# Access Compliance Report

## Public Rights-of-Way

Intersection ID: 5868	Main Street: PIMPERNEL_RD	Cross Street: PARTRIDGEBERRY_DR	Location: NW
ADA ID: E2085987A3DF	Ramp Type: Perp	Initial Pass/Fail: Fail	Overall Compliance: No
Severity Score: 12.5			
Codes/Mitigation Info/Possible Solution		Field Measurements/Component Compliance

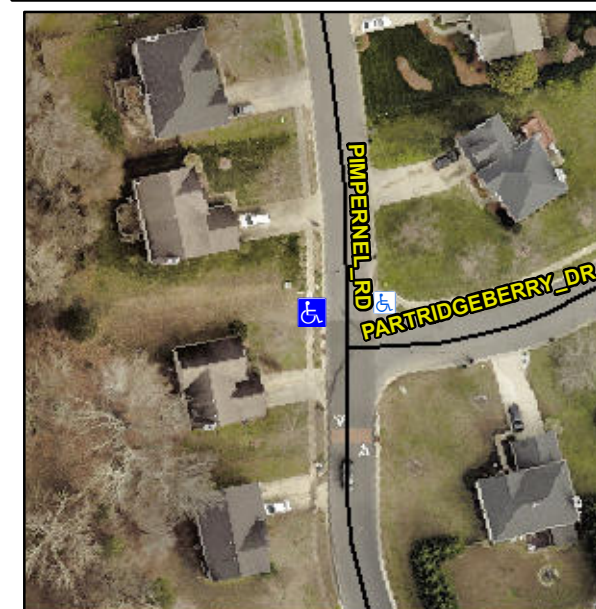
**Not Found, R304.2.2**

Compliance	Description	Data	Compliance	Description	Data
N/A	Ramp Length (in)	47.0	No	Ramp Slope (%)	11.1
Yes	Ramp Width (in)	68.1	Yes	Ramp XSlope (%)	0.3
N/A	Flare Type LT	N/A	N/A	Flare Type RT	N/A
N/A	Flare Slope LT (%)	N/A	N/A	Flare Slope RT (%)	N/A
N/A	Flare Traversable LT?	N/A	N/A	Flare Traversable RT?	N/A
N/A	Landing Length (in)	N/A	N/A	DWS Provided?	N/A
N/A	Landing Width (in)	N/A	N/A	DWS Contrast?	N/A
N/A	Landing Slope (%)	N/A	N/A	DWS Length (in)	N/A
N/A	Landing X Slope (%)	N/A	N/A	DWS Full Width?	N/A
N/A	Landing Curb? (Y/N)	N/A	N/A	DWS Offset (in)	N/A
N/A	Shared Landing?	N/A			
N/A	Gutter Ponding?	N/A	N/A	Gutter Slope (%)	N/A
N/A	Gutter Lip Ht (in)	N/A	N/A	Gutter X Slope (%)	N/A
N/A	Painted X Walk1?	No	N/A	Painted X Walk2?	N/A
	X Walk 1 Direction	To E		X Walk 2 Direction	N/A
N/A	X Walk 1 Width (in)	N/A	N/A	X Walk 2 Width (in)	N/A
	X Walk 1 Slope (%)	8.2		X Walk 2 Slope (%)	N/A
	X Walk 1 X Slope (%)	0.0		X Walk 2 X Slope (%)	N/A

**Remove & Replace Entire Ramp.**
